Subject: Response to NDEP September 18, 2008 Comments
Data Validation Summary Report (DVSR), Phase B Source Area Investigation
Soil Gas Survey, Tronox LLC Facility, Henderson, Nevada
Dated August 25, 2008

Tronox Response to Comments

September 18, 2008 NDEP Letter Regarding Data Validation Summary Report (DVSR), Phase B Source Area Investigation Soil Gas Survey, Tronox LLC Facility, Henderson, Nevada (August 2008)

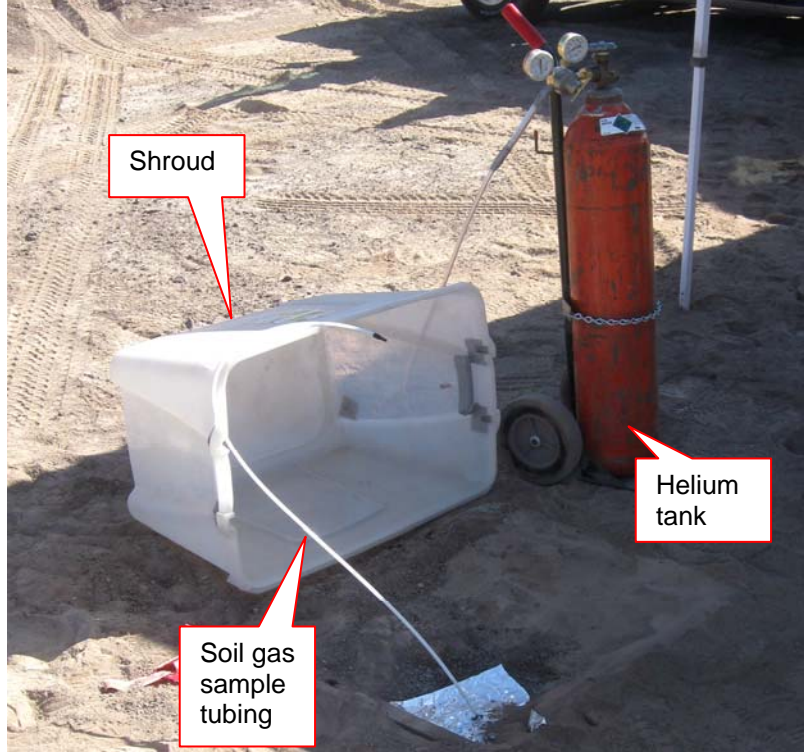
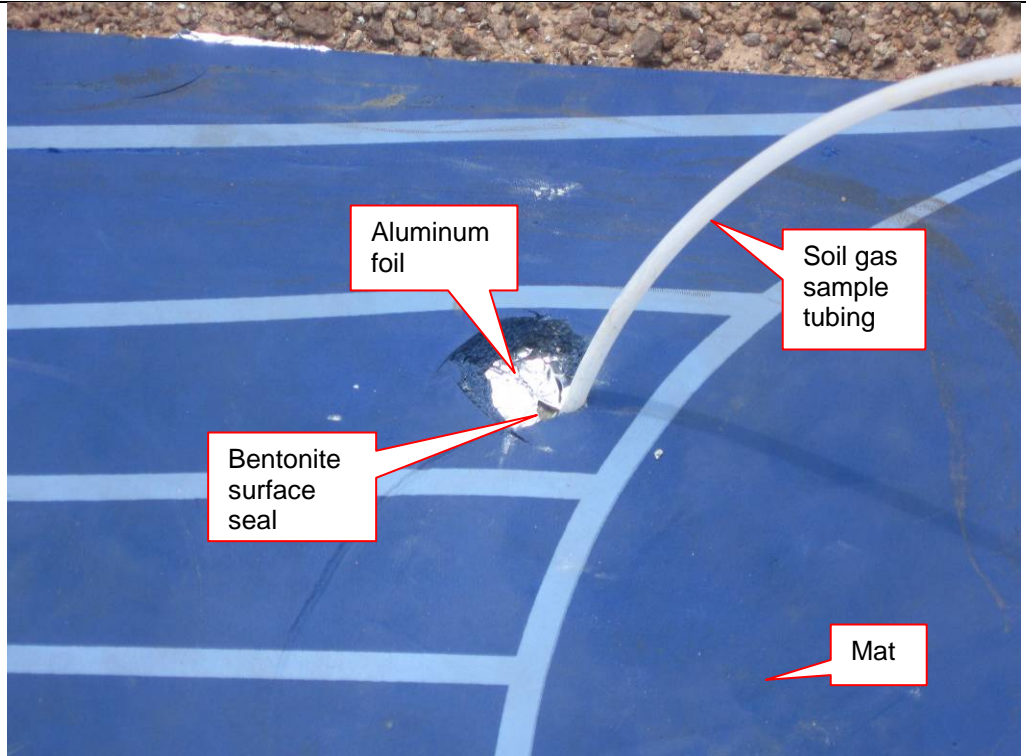
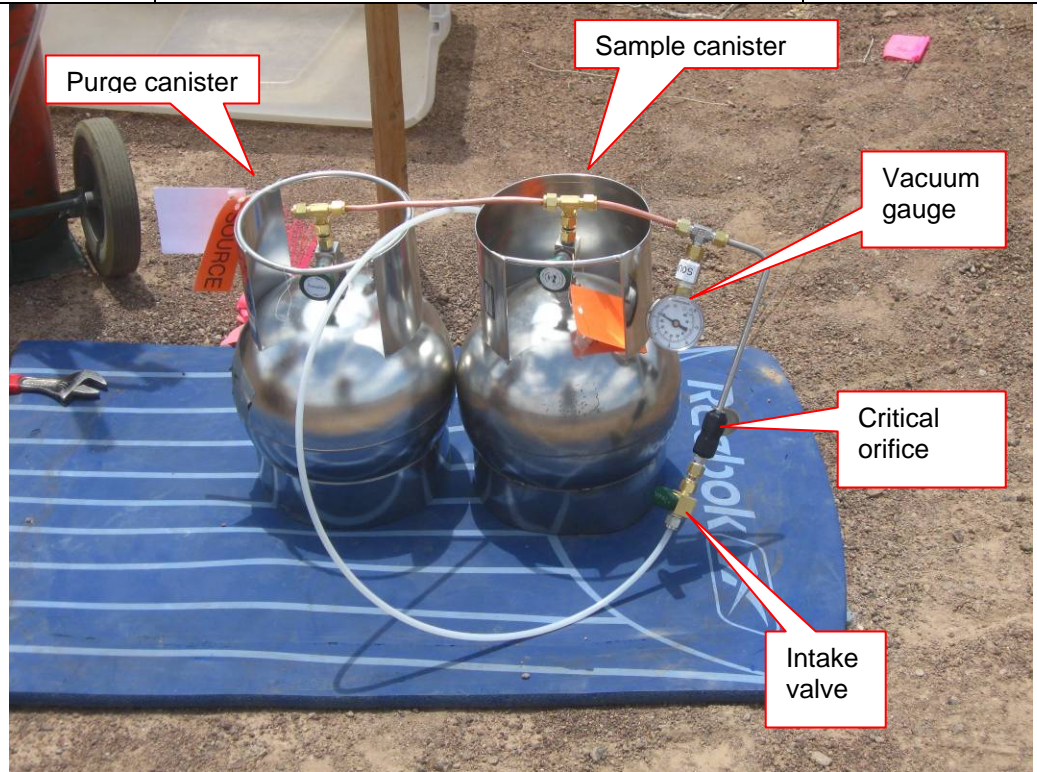
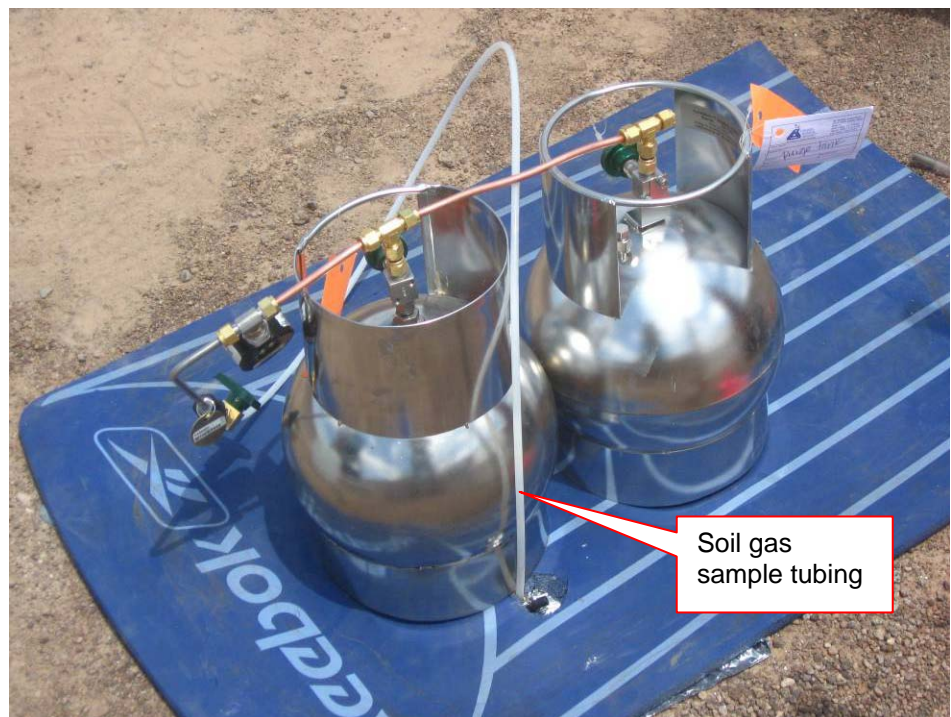
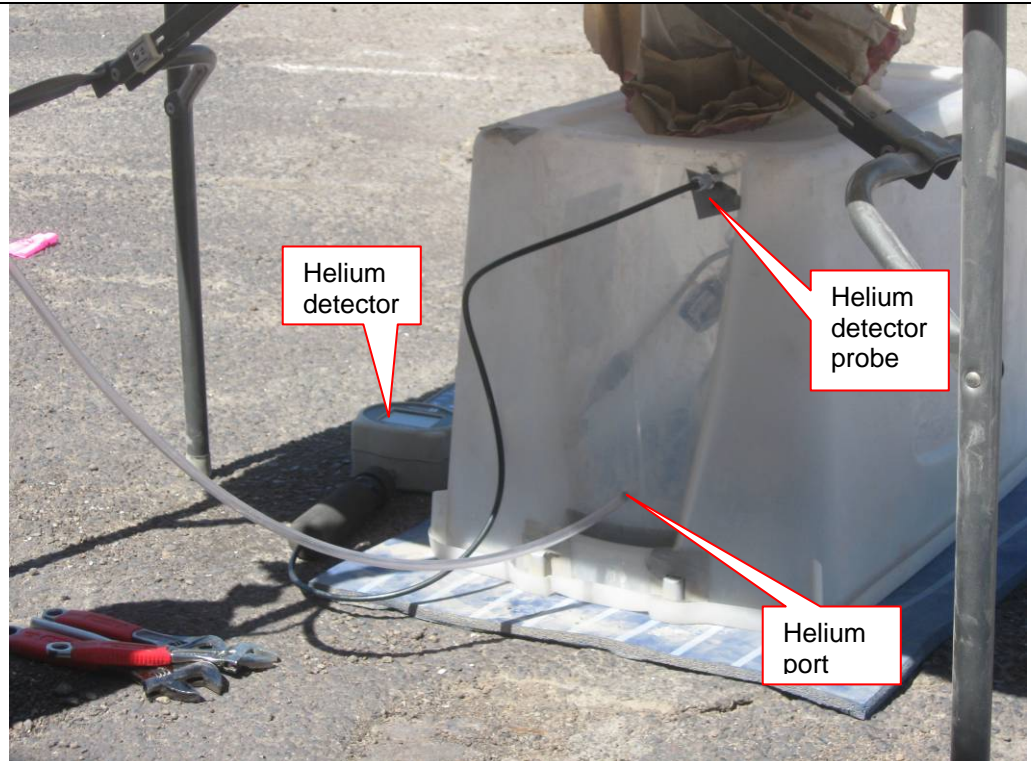
- 1 Helium Analysis:** Review of the laboratory reports from Columbia Analytical Services shows that helium analysis, using a modified method 3C, was performed on the Summa canister samples. It is unclear why helium analysis was required and why the soil gas samples would be exposed to helium. The DVSR should provide details on why helium analysis was performed along with a discussion of what impact helium detection in a sample has on the TO-15 results. For example, does helium indicate a soil gas sample was influenced from a purge gas? If helium detection in a sample does impact the VOC results the DVSR should also provide a validation of the helium analysis along with a discussion of the impact of helium results on the VOC data.

For the Phase B soil gas survey, the above-ground portion of the sample system (i.e., summa canisters, flow-controller, vacuum gauge, valves and tubing connections) was placed under a shroud (plastic box). Helium gas (provided by a compressed gas vendor) filled the shroud, creating an atmosphere surrounding the sampling system with between 5% to 55% helium. A hand-held helium meter was used to monitor the atmosphere within the shroud to ensure that the helium concentration was maintained as each sample was collected (see the attached **photos numbered 1 through 6**).
